**FEDERAL AVIATION ADMINISTRATION
AIRWORTHINESS DIRECTIVES**

BIWEEKLY 2021-07

3/15/2021 - 3/28/2021

Figure 1 to paragraph (g)(1)(iii); placard location on bezel

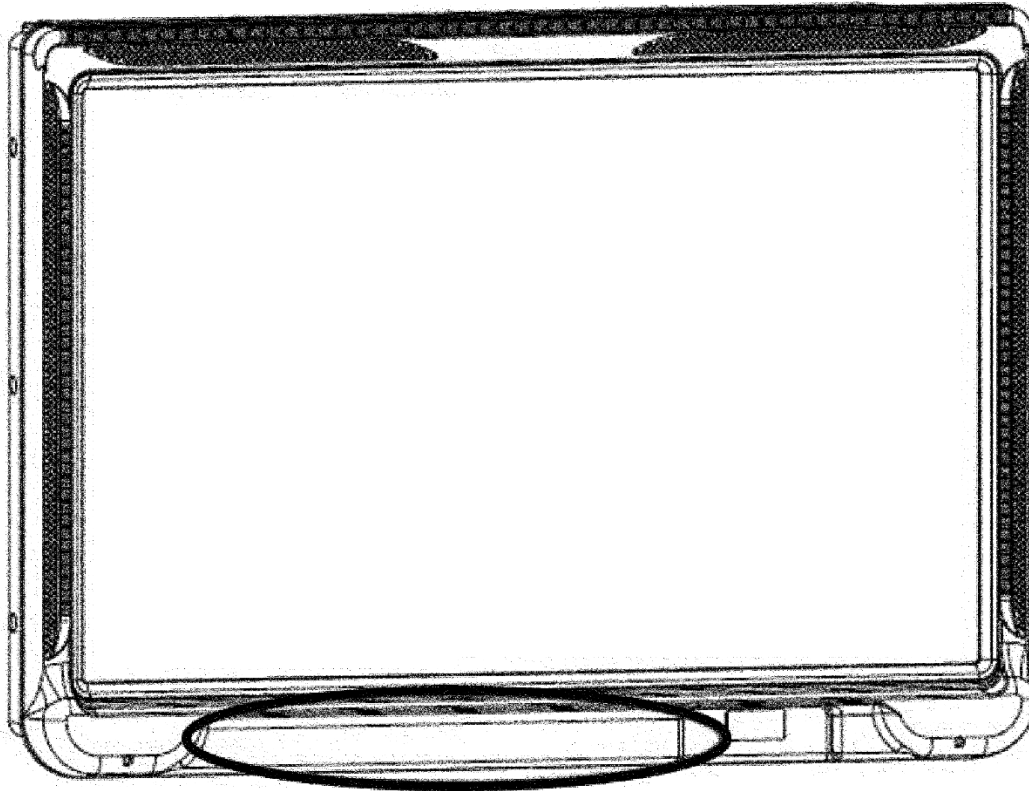
(iii) Install the placard on the bottom of each aircraft primary flight display bezel in the area depicted in figure 1 to paragraph (g)(1)(iii) of this AD.
